Technical Service Bulletin: tsb101158

Ferrous Cast Ductile Iron Piston Introduction

This service/parts topic is to introduce the new single piece Ferrous Cast Ductile (FCD) iron pistons for the QSK45 and QSK60 engines and secondly to introduce a new Service Practice change for articulated pistons used in QSK45 and QSK60 engines.

Fig. 1. Cylinder Liner Part Number Location

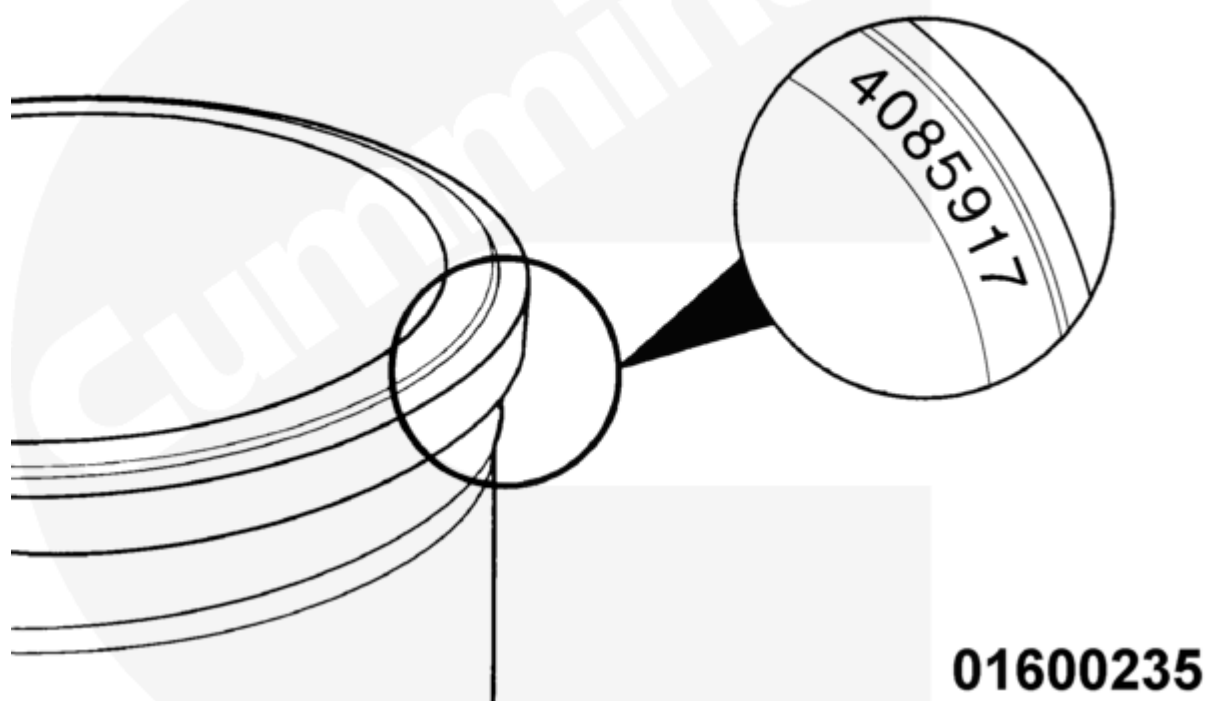
When the new hardened cylinder liner is unused it is duller in appearance as compared to the old cylinder liner because of the nitride hardening. However, the only certain method to tell the difference between the cylinder liners is by part number identification, stamped into the cylinder liner. See Fig. 1. Visual inspection of the top piston ring is also required to determine correct piston ring part number. The top piston ring **must** be installed correctly, top side up, because the ring face is no longer symmetric. See Fig. 2.
